MEMORANDUM

DATE:	April 1 2019	
TO:	Tim Blair, Supervisor, Planning Vancouver Fraser Port Authority	Email: tim.blair@portvancouver.com
PREPARED BY:	Katie McKinnon Matt Johnston	Regulatory Advisor, Trans Mountain Noise Specialist, RWDI
RE:	Request to amend PER VFPA 15-322 Condition 37 Noise Limits for Westridge Marine Terminal Construction

Figure 2: BC OGC Ambient Sound Level vs. Measured Sound Level at R3

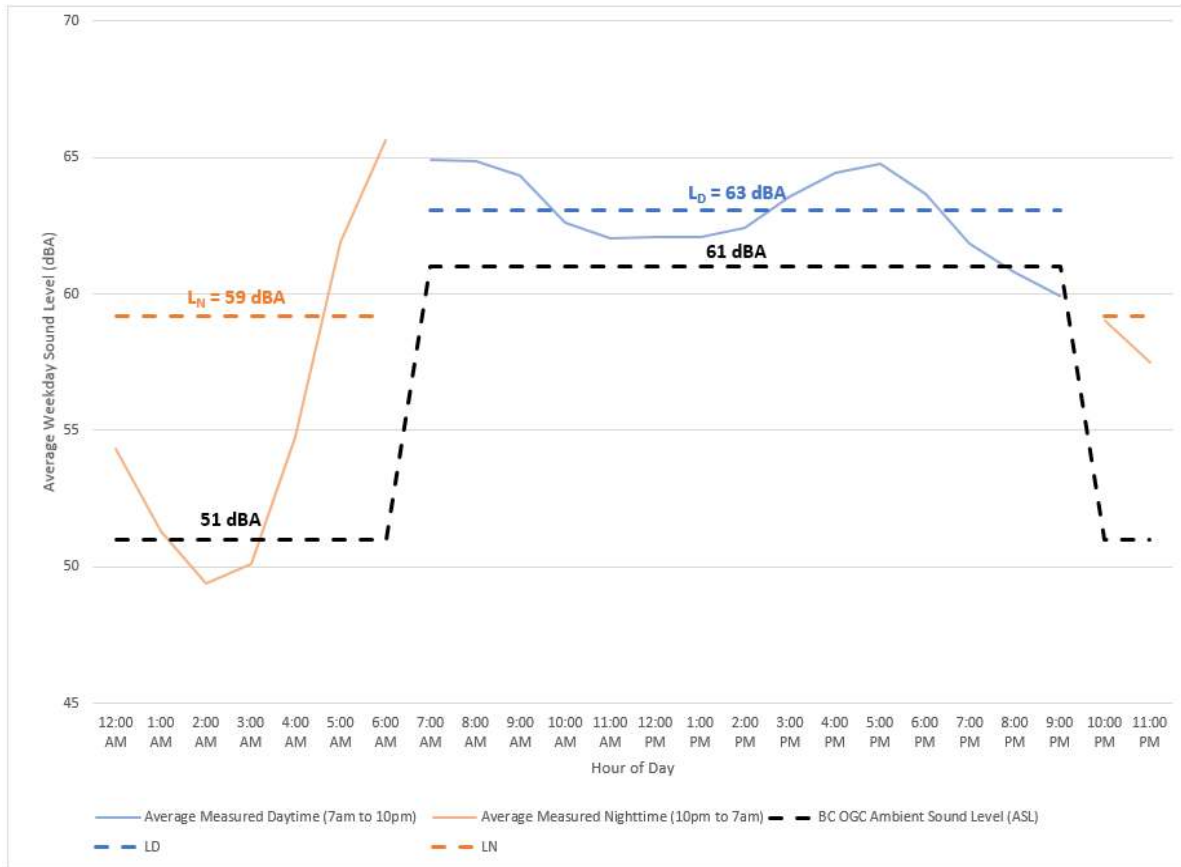
Throughout the monitoring conducted to date, it is generally found that the measured levels are higher than the expected BC OGC ASL. To determine the true ASL, the sound levels during a period when there were no construction activities at WMT was reviewed (August 30, 2018 to September 17, 2018). Figure 2 shows the average weekday measured sound level per hour at R3 compared to BC OGC's assumed ASL using dwelling density and roadway proximity adjustments and the hourly recorded levels are provided in Attachment A.

As shown in Figure 2 and Attachment A, the measured sound level typically always exceeds the BC OGC ASL. This demonstrates that the ASL as dictated by the BC OGC general method is not appropriate for this monitoring location.

The morning rush hour begins at 5 am which is not anticipated in the BC OGC approach and is the source of the high night-time average equivalent sound level (LN) result. The average ASL between 5 am and 7 am is 64 dBA which is similar to the daytime average equivalent sound level (LD). Therefore, the following is requested as a part of the noise limit amendment:

- Daytime hours be modified to include the hours 5 am to 10 pm and nighttime hours include 10 pm to 5 am for the purpose of compliance monitoring.

Figure 3: R3 Hourly Measured Data with Shifted Day/Night Split

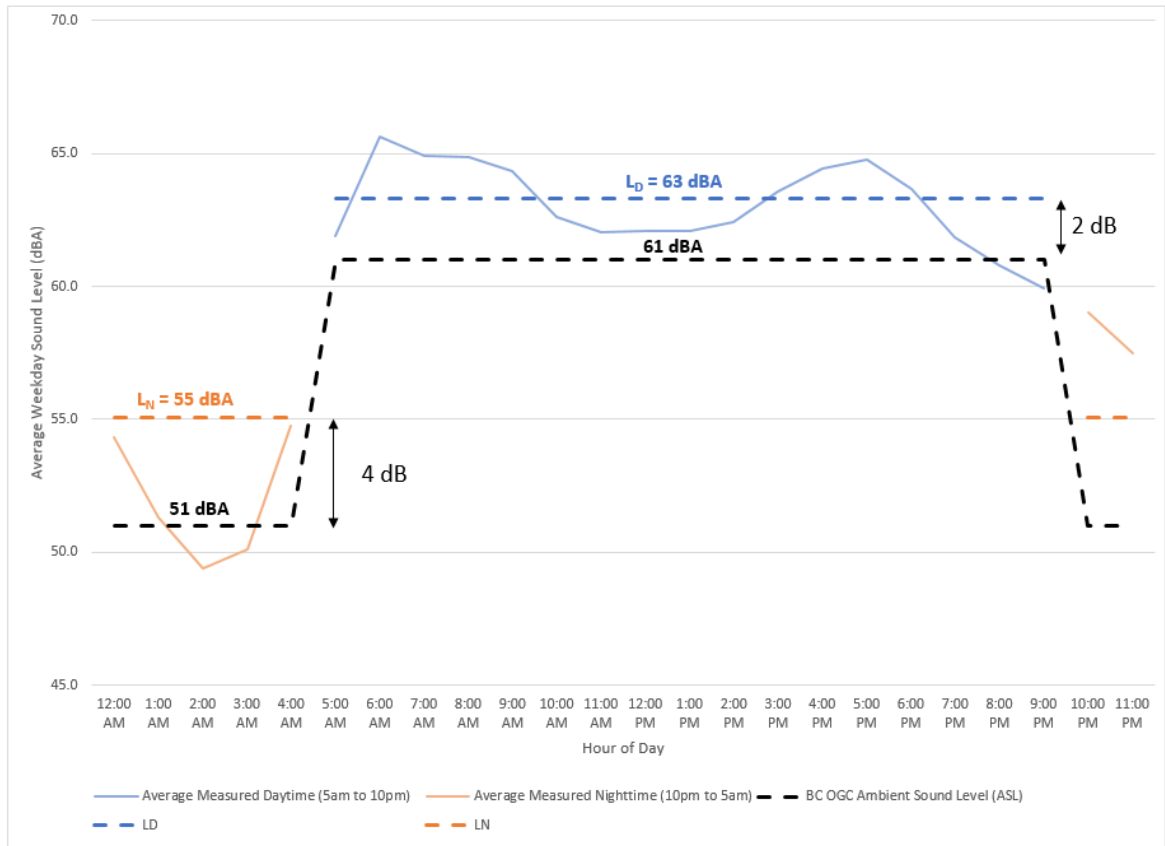
This will align levels with the actual diurnal patterns that are occurring. The modified day/night split proposed for the average weekday measured sound level per hour at R3 compared to BC OGC's assumed ASL are shown in Figure 3.

As shown in Figure 3, the modified day/night split better represents the differences between day and night, but does not address the BC OGC ASL for this location. The remaining issue is that the measured levels are still greater than the BC OGC ASLs. According to the BC OGC Noise Guidelines, receptors where the measured ASL is greater than the expected ASL, a “Class A2” adjustment is applied. Table 1 summarizes the application of the Class A2 adjustment.

- The PSLs at R3 be updated to 68 dBA and 60 dBA for daytime and nighttime, respectively.
